29 March 2022

**Re: DA: D/2021/1550: 82-106, 110-122, and 56-78 Oxford Street DARLINGHURST NSW 2010**

Current Group 2 First Floor "Restoration Plan" (Source: Place Studio Drawing AR-DA-2-1002)

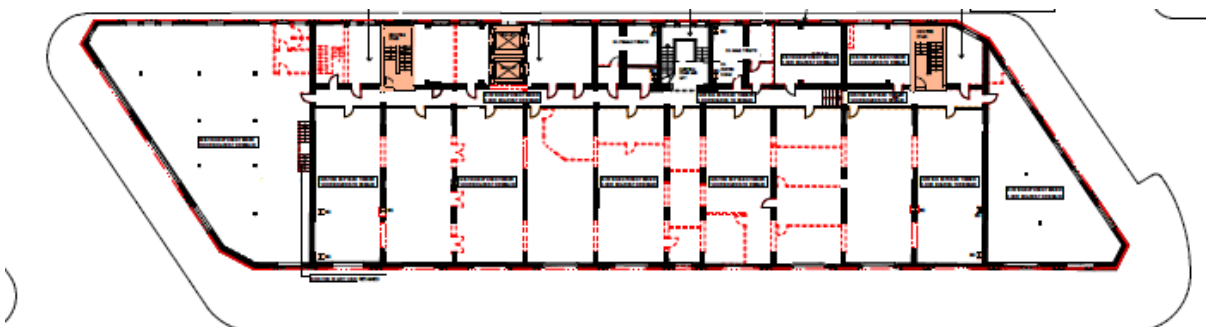
This concern was highlighted earlier by the Trust when we commented on the early works package, and we still have the same reservations with this current approach. The current description of what is in fact a *demolition plan* instead being referred to as a "Restoration Plan" in the architectural drawing package is one reason for this scepticism.

The scope of demolition work has certainly been reduced in certain areas, as can be seen in the comparative selection of drawings from the various applications. All of the below schemes have been justified at each stage in heritage terms as being necessary for the new works to be carried out, yet each time the extent of demolition is (fortunately) reduced. This is why it is necessary to consider extensive demolition works as part of an overall application.
